VIA E-MAIL AND OVERNIGHT MAILMindy Nguyen
City of Los Angeles
Department of City Planning
221 N. Figueroa St., Suite 1350
Los Angeles, CA 90012
E-Mail: mindy.nguyen@lacity.org**RECEIVED**
CITY OF LOS ANGELES**JUN 03 2020****MAJOR PROJECTS
UNIT**Re: Case No. ENV-2018-2116-EIR
Project name: Hollywood Center Project
Comments on Draft Environmental Impact Report

This letter is submitted on behalf of our client Ned Pan, Inc. ("Ned Pan"), the owner of the Pantages Theater at 6233 Hollywood Boulevard. We appreciate this opportunity to present comments on the Draft Environmental Impact Report ("DEIR") for the Hollywood Center Project, the ("Project"), which is proposed to be developed on an approximately 4.46-acre site generally bounded by Yucca Street on the north, Ivar Avenue on the west, Argyle Avenue on the east, and Hollywood Boulevard on the south (the "Project Site").

Figure 1 – Veneklasen Receptor Location Map

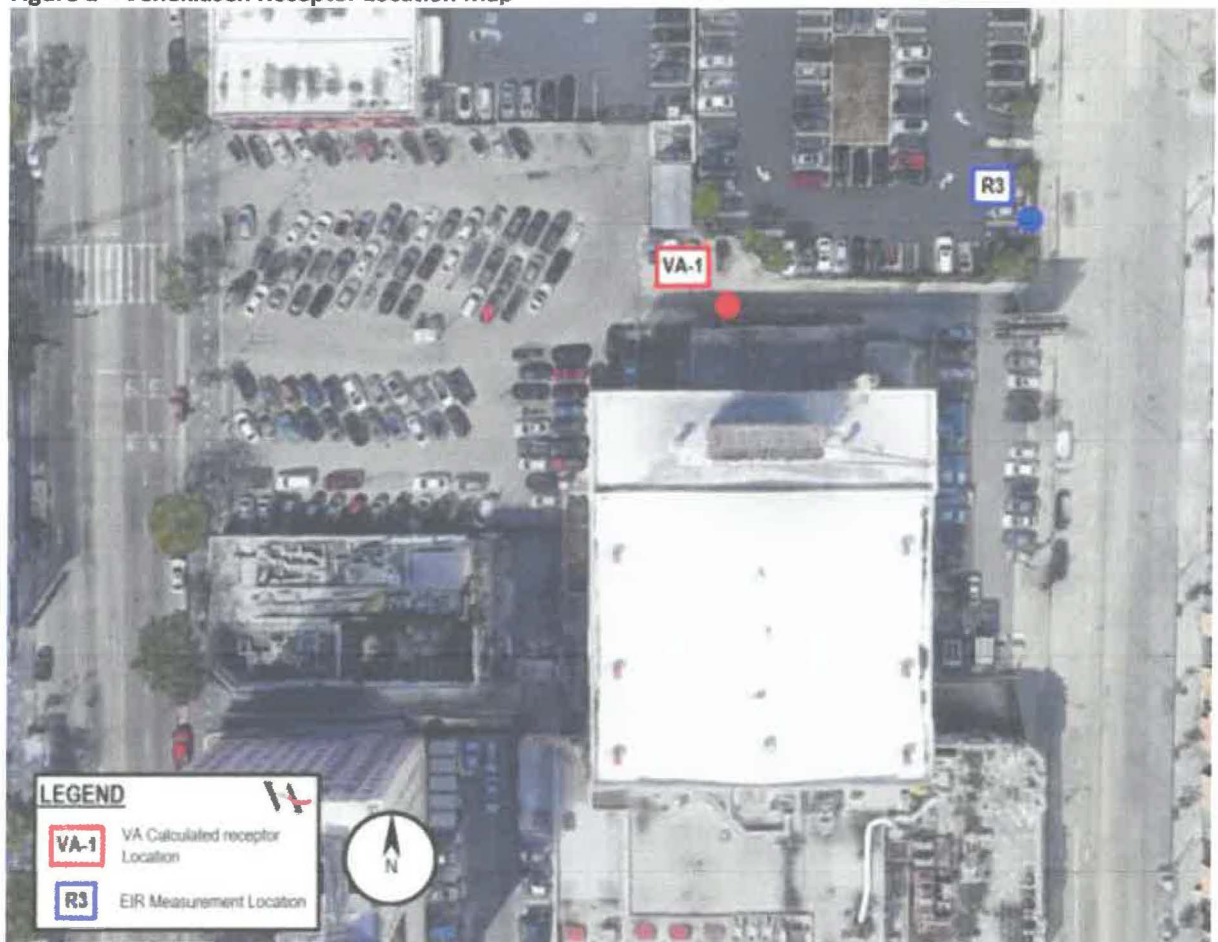
Draft EIR Page IV.I-21, Table IV.I-5: The measured noise level at measurement position R3 is not representative of the noise levels at the back of the Pantages Theater. The measured ambient level for the Pantages Theater indicated in Table 1, Appendix K-2 states that the measured level is 60.1 dBA at R3 along Argyle Avenue. This is not representative of the sound levels in the access alley behind the theater where there is some exposure to Vine Street, but also significant acoustical shielding because of building geometry which does not appear to be accounted for. Veneklasen performed a distance and angle attenuation analysis at Veneklasen receptor location VA-1 which is shown in **Figure 1**. Using the measured level at R3 along Argyle Avenue and the measured level at R2 on Vine Street, Veneklasen calculated the ambient noise level at VA-1 to be approximately 56 dBA, accounting for increased distance and reduced angle of exposure. As such, the significance thresholds identified in Table IV.1-19 and Table IV.1-10 for the Pantages Theater (receptor location no. 9) are significantly higher, which has the effect of understating the impact of construction noise on the Pantages Theater. Additional sound level measurements should be performed of suitable duration to determine the ambient levels in the alley behind the Pantages Theater. Veneklasen would suggest a minimum measurement duration of 72 hours during normal weather conditions.

Additionally, once the subject project is constructed, the alley behind the Pantages will be completely shielded from Vine Street, and the angle of exposure to traffic noise from Argyle Avenue will be further reduced, likely causing the noise levels to decrease further. Veneklasen estimates the post-construction ambient noise level in the alley behind the Pantages Theater to be approximately 47 dBA.

Figure 2 – Background Music Distance Attenuation Locations

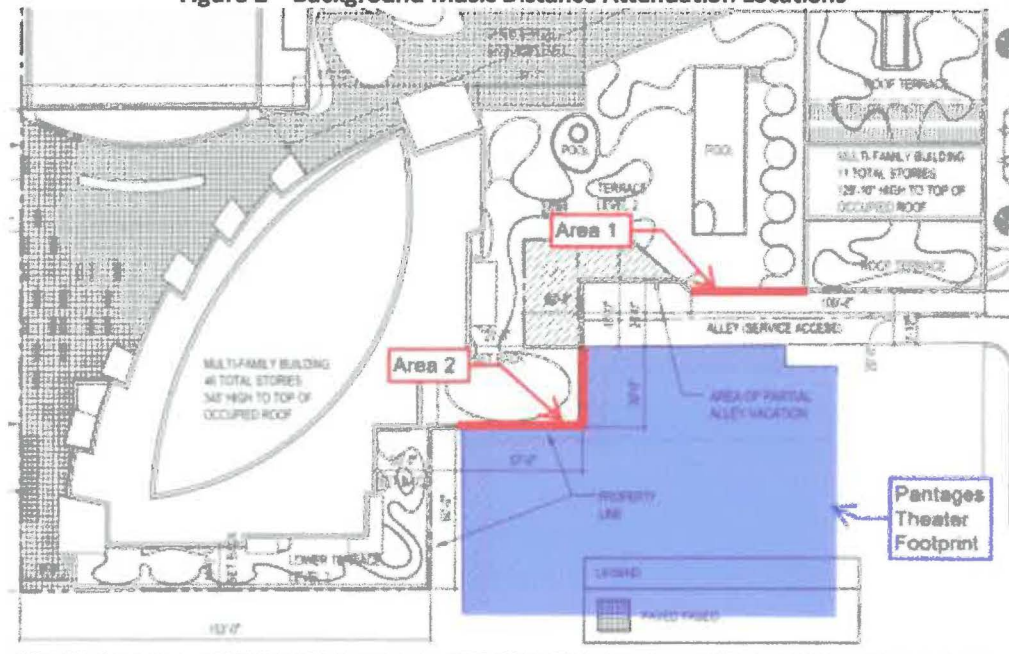
Draft EIR Table IV.I-12 and Page IV.I-51: On page IV.I-51 it is stated that the "sound level of the music speakers is conservatively assumed to be 75 dBA at 25 feet, which is more than 5 dBA higher than the ambient noise levels in the vicinity of the Amenity Deck (Level 2), East Site, which ranges from approximately 60.1 to 68.3." The predicted noise level pre-construction is 56 dBA and as stated in **Item I** above, Veneklasen predicts the post-construction noise level from Argyle Avenue to be about 47 dBA. Both predicted pre-construction and post-construction noise levels are significantly lower than the assumed 60.1 stated in the Draft EIR indicating that additional review and analysis should be performed. The areas from which Veneklasen performed a distance loss calculation between the Amenity Deck (Level 2), East Site and the Pantages Theater are shown in **Figure 2** below:

The distance from Area 1 to the Pantages Theater is 20 feet and the Distance from Area 2 to the Pantages Theater is 0 feet. For the purpose of an accurate analysis, Veneklasen has assumed a minimum distance of 5 feet from the nearest music speaker for Area 2. The results of these calculations are shown in **Table 3** below:

Figure II-19 indicates that under the East Site Hotel Option, there will be a swimming pool located in Area 2 is as shown in **Figure 2** above. Using the same calculation methods to determine the sound levels from speech at the Pantages from this area, the noise level will be 80 dBA at the Pantages. This would be a significant on-going impact and this area cannot be occupied by a pool, as any operation will significantly exceed both proposed interior noise guidelines and could negatively impact rehearsals and other theater operations.

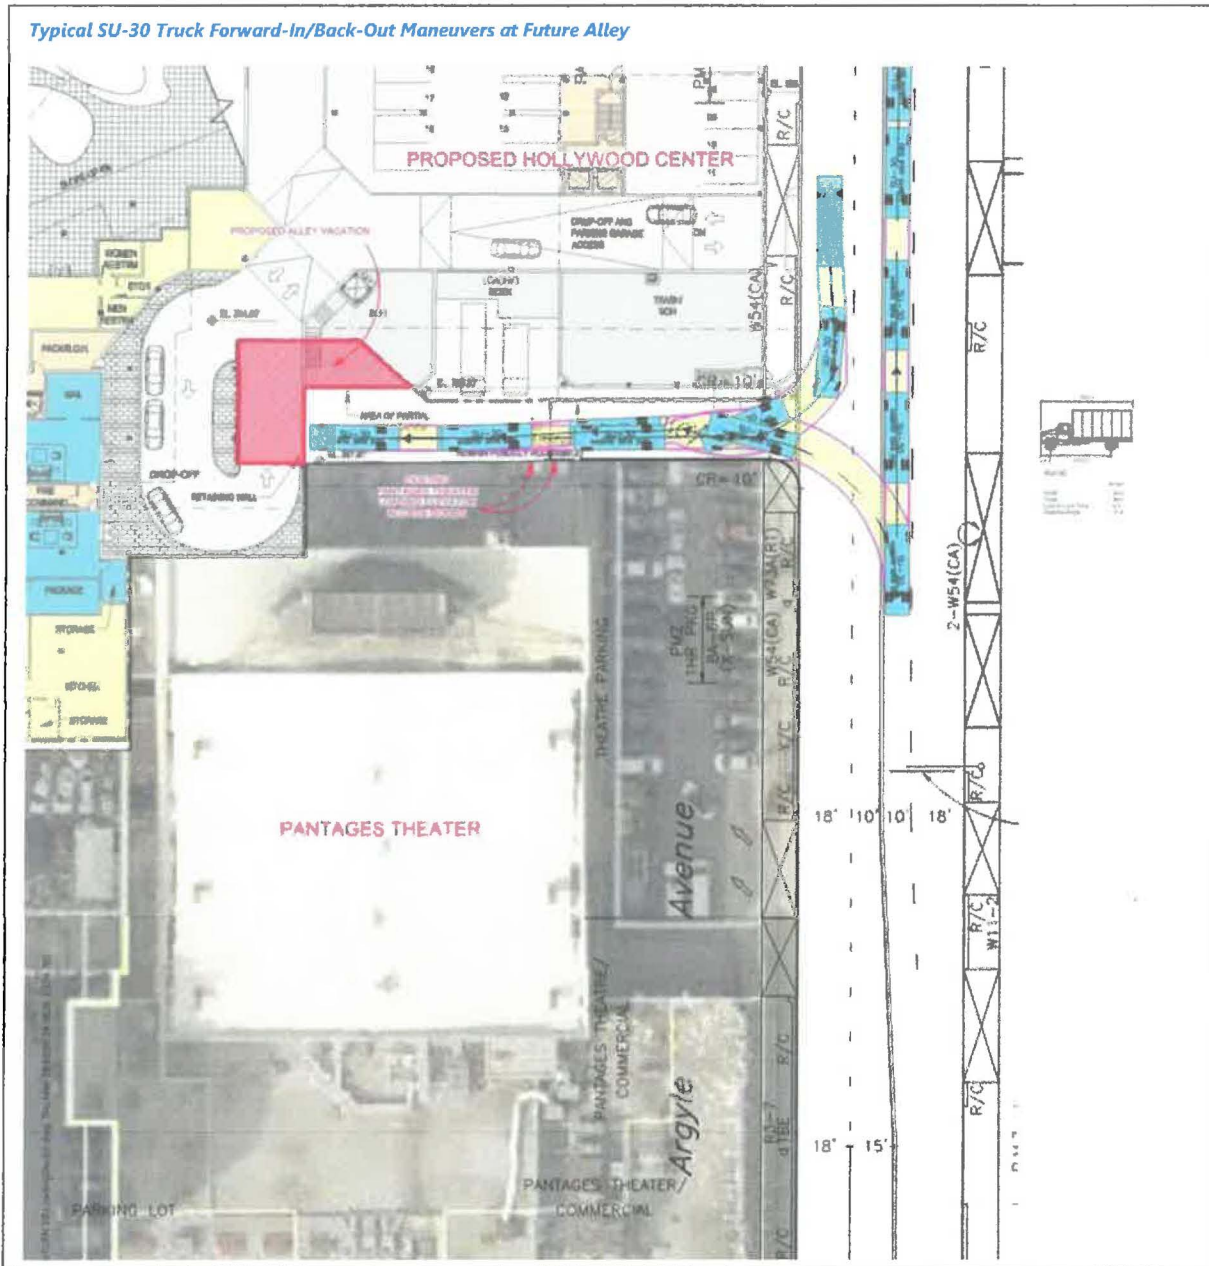
Figure 2D, which indicates that Project drop-off/pick-up area will occupy the vacated portion of the alley, is consistent with Figure II-14 in the Description of Project section of the DEIR, which indicates that this vacated portion of the alley is to have walls constructed separating it from the remaining alley, thus creating a dead-end condition for the shared alley with no turnaround space for service trucks. The alley turnaround area is currently used for daily delivery trips by the Pantages Theatre, trash pickups, and other services, and needs to remain usable without impedance. Under the existing conditions, standard single-unit trucks (SU-30) can utilize the turnaround area to depart without having to back out of the alley:

Under the proposed conditions, a typical SU-30 truck will no longer be able to turn around in this dead-end alley, and must back out of the alley driveway in order to depart, thereby adding even more truck movements on Argyle Avenue. Below is a typical scenario in which a SU-30 truck would have to maneuver in order to arrive and depart the alley:

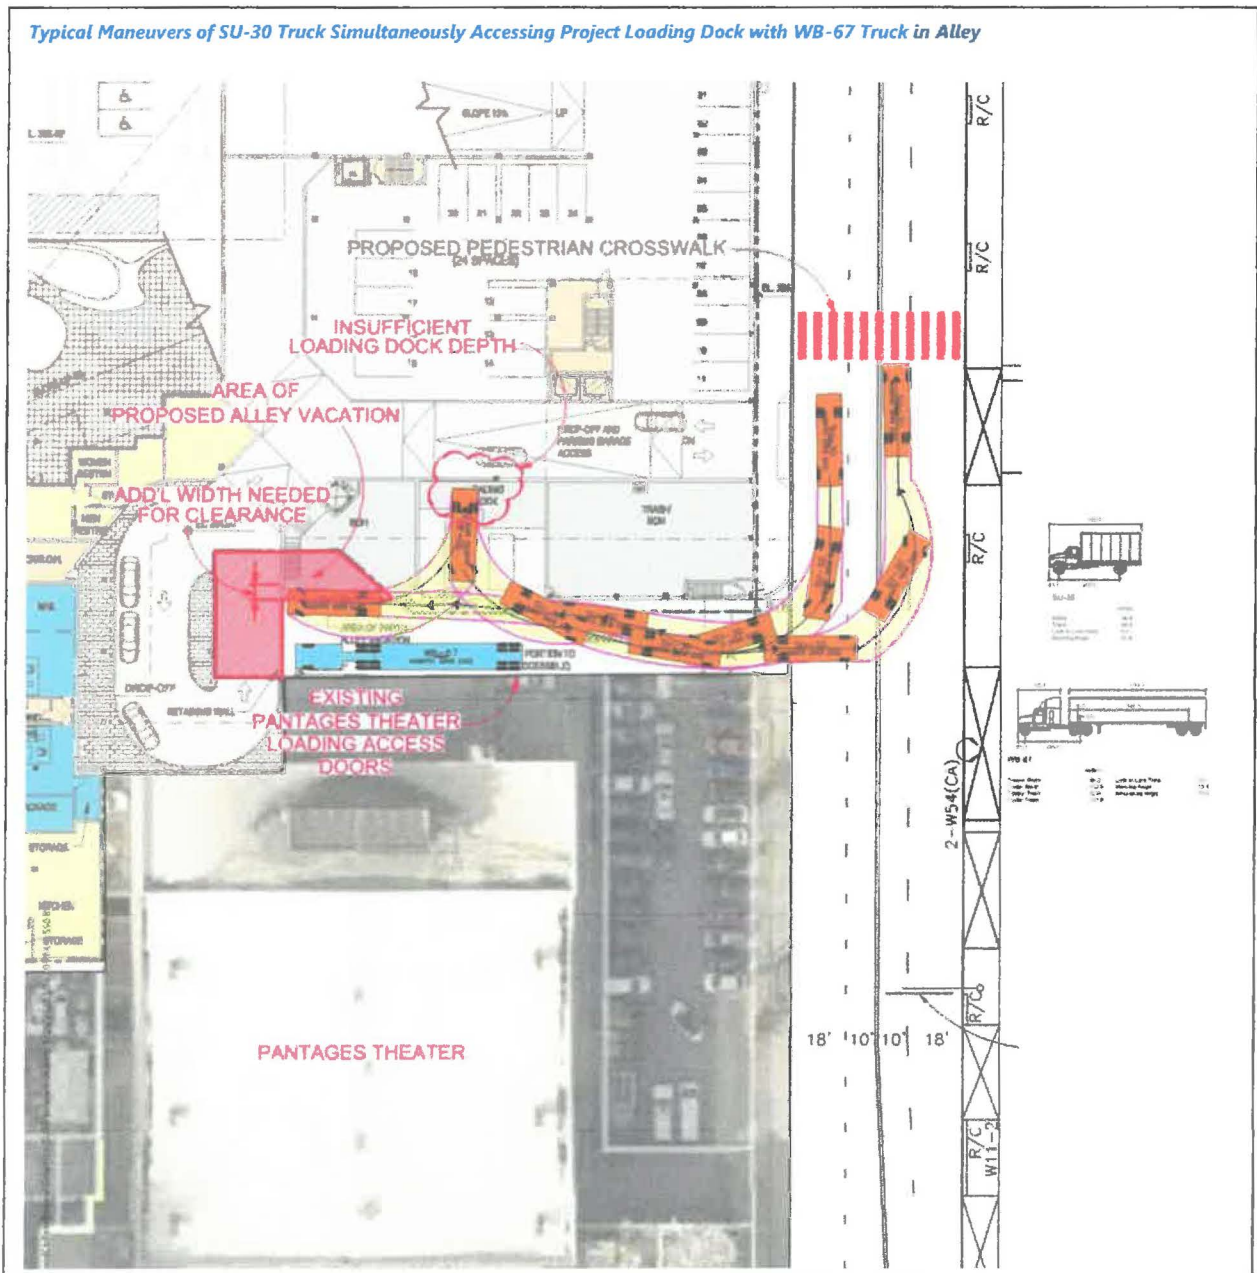
The safety concerns of requiring daily delivery trucks for the Pantages and other south side users of the alley to now back out rather than turn around needs to be analyzed and fully addressed. The analysis needs to consider having the trucks back up past the Pantages elevator and other alley activities, across the

Further, when trucks serving the Pantages Theatre occupies a portion of the currently proposed alley for loading and unloading, the Project loading dock is rendered inaccessible, as it does not have sufficient depth to accommodate the simultaneous uses that can occur within a shared use alley such as this one. An example of such a condition is shown below:

As shown above, in order for a SU-30 truck to access the project loading dock while a semi truck is positioned in the alley, additional width is needed in order for the su-30 truck to bypass the WB-67 semi

- Widen and redesign the Project loading dock and the shared alley for both the Project and the Pantages Theatre so as to provide sufficient width turnaround for daily delivery vehicles, and with adequate flare at the driveway connection to Argyle Avenue to accommodate large semis to access the alley and to allow daily delivery vehicles to utilize the alley simultaneously with the presence of a parked semi in the alley. This is required for safe access as well as continued operations of the existing uses, which is critical for the Pantages Theatre. Without an adequate alley width and flared corner conditions at the northeast corner of the alley, the loading and unloading of the Project at its currently proposed loading dock would highly disrupt the operation of the Pantages Theatre. Conversely, Trucks serving the Pantages Theatre in the Alley would also render the currently proposed Project loading dock inaccessible. If either operation defaults to the effort to mutually accommodate each other's access of an inadequately designed alley and loading dock configuration, the service vehicles waiting for access would generate further disruption and congestion on Argyle Avenue in this block.
